# 802.1CB maintenance

## "265" – FRER MatchRecoveryAlgorithm

IEEE 802.1 Maintenance TG  
April, 2020

## Talker fails (1):

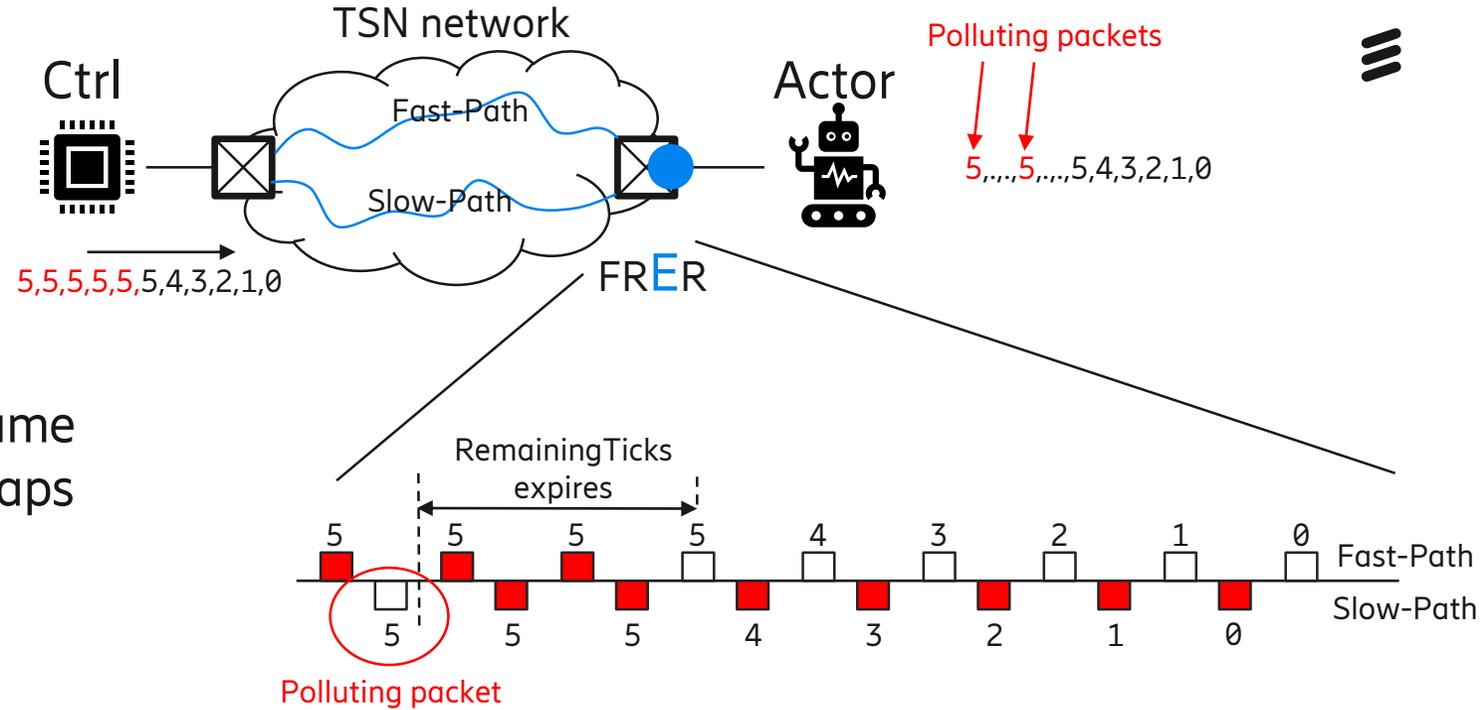
- repeatedly transmit packets with the same sequence\_number subparameter (perhaps repeating exactly the same packet)
- here packet "5"

- works **only on multiple Member Streams** (frerSeqRcvyIndividualRecovery=FALSE)
  - Packets discarded by the MatchRecoveryAlgorithm will NOT cause the variable RemainingTicks (7.4.3.2.4) to be reset.
- result: first packet "5" accepted, than until RemainingTicks expires all packet "5" dropped. Next packet "5" accepted and again until RemainingTicks expires all packet "5" dropped ...

## Talker fails (2):

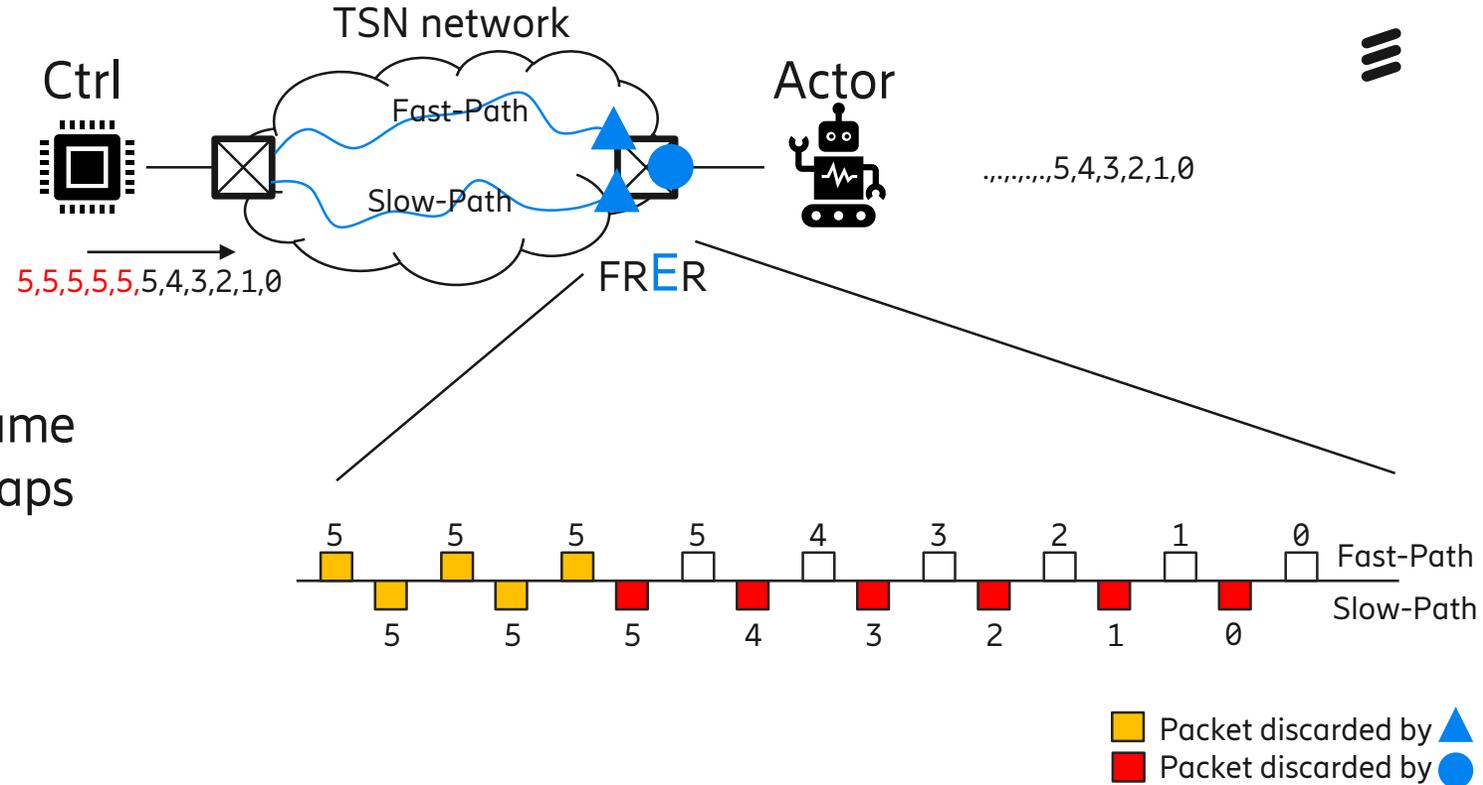
- repeatedly transmit packets with the same sequence\_number subparameter (perhaps repeating exactly the same packet)
- here packet "5"

- ▲ — works on an **individual Stream** (frerSeqRcvyIndividualRecovery=TRUE)
  - Packets discarded by the MatchRecoveryAlgorithm will cause the variable RemainingTicks (7.4.3.2.4) to be reset.
  - result: first packet "5" accepted, than all packet "5" dropped
- — additionally it works **also on multiple Member Streams** (frerSeqRcvyIndividualRecovery=FALSE)
  - result: first packet "5" accepted, than RemainingTicks expires, but no more packet

## Relay fails (1):

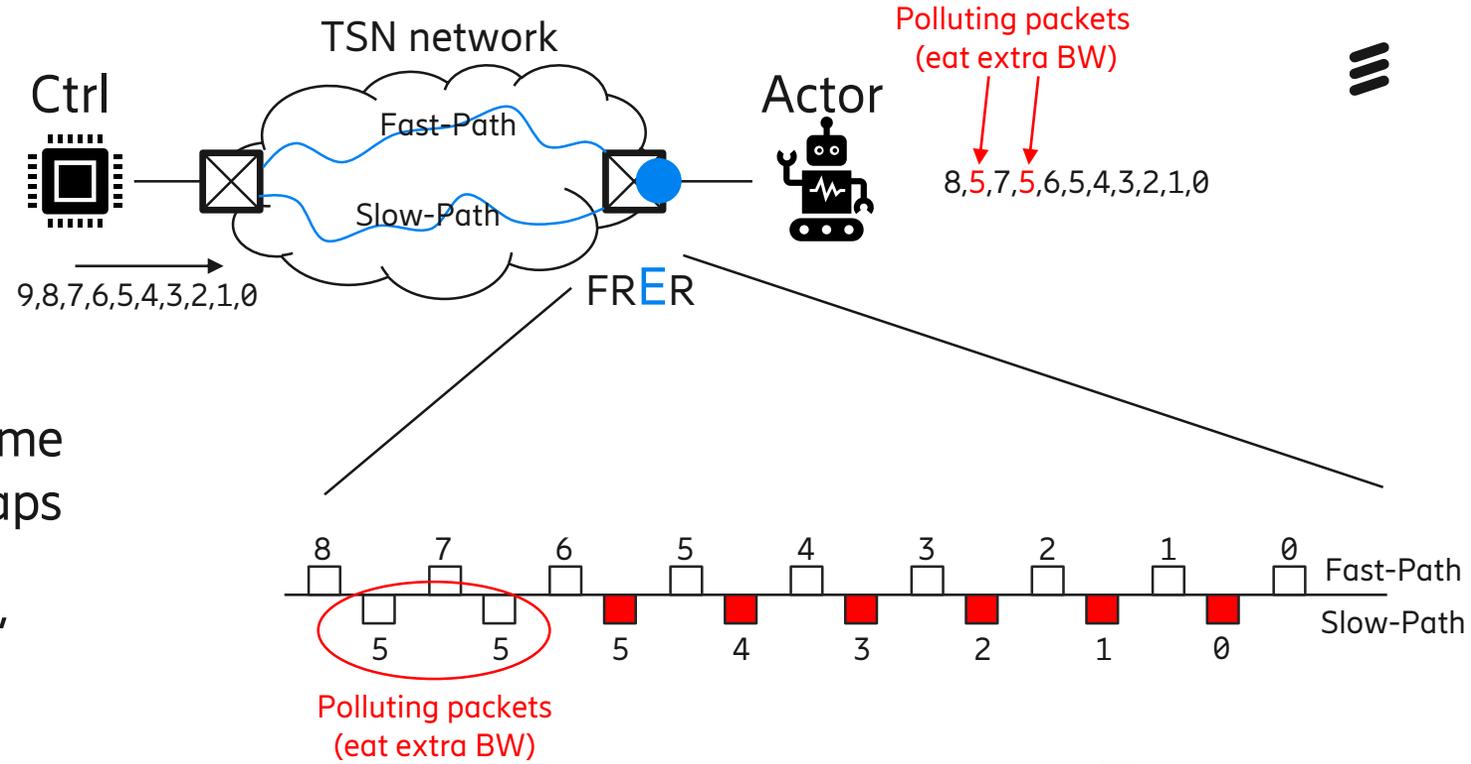
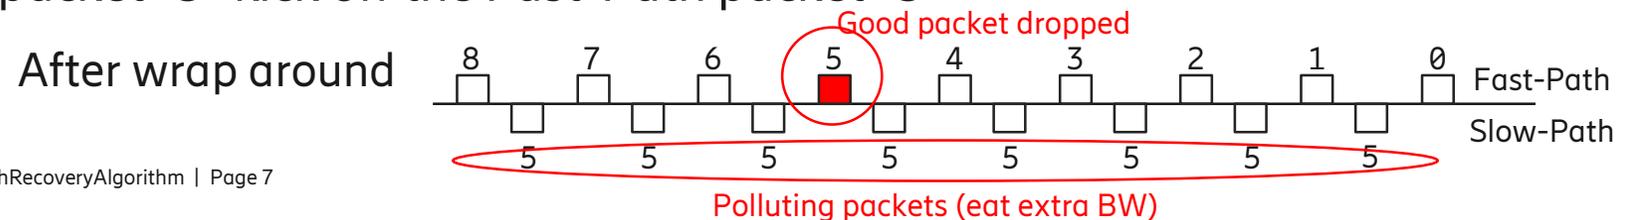
- repeatedly transmit packets with the same sequence\_number subparameter (perhaps repeating exactly the same packet)
- here relay on Slow-Path fails, packet "5"

- works **only on multiple Member Streams** (frerSeqRcvyIndividualRecovery=FALSE)
  - Packets discarded by the MatchRecoveryAlgorithm will NOT cause the variable RemainingTicks (7.4.3.2.4) to be reset.
- result: first packet "5" accepted, after packet "6" all packet "5" accepted until wrap around. After wrap around the Slow-Path packet "5" kick off the Fast-Path packet "5"

## Relay fails (2):

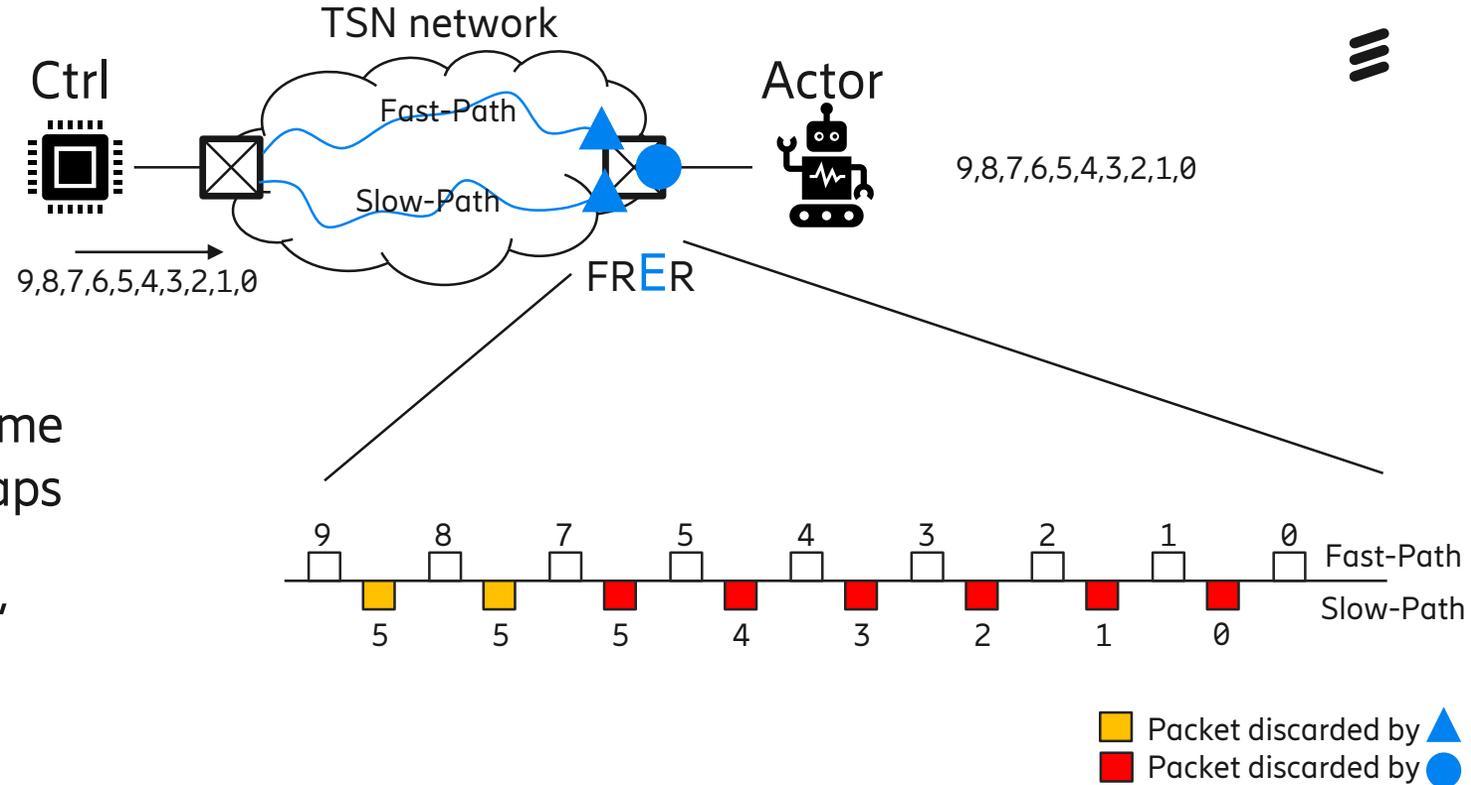
- repeatedly transmit packets with the same sequence\_number subparameter (perhaps repeating exactly the same packet)
- here relay on Slow-Path fails, packet "5"

- ▲ works on an **individual Stream** (frerSeqRcvyIndividualRecovery=TRUE)
  - Packets discarded by the MatchRecoveryAlgorithm will cause the variable RemainingTicks (7.4.3.2.4) to be reset.
  - result: first packet "5" accepted, than all packet "5" dropped
- additionally it works **also on multiple Member Streams** (frerSeqRcvyIndividualRecovery=FALSE)
  - result: first packet "5" accepted, no issue at wrap around (Slow-Path packets already dropped by the Individual Recovery 😊)
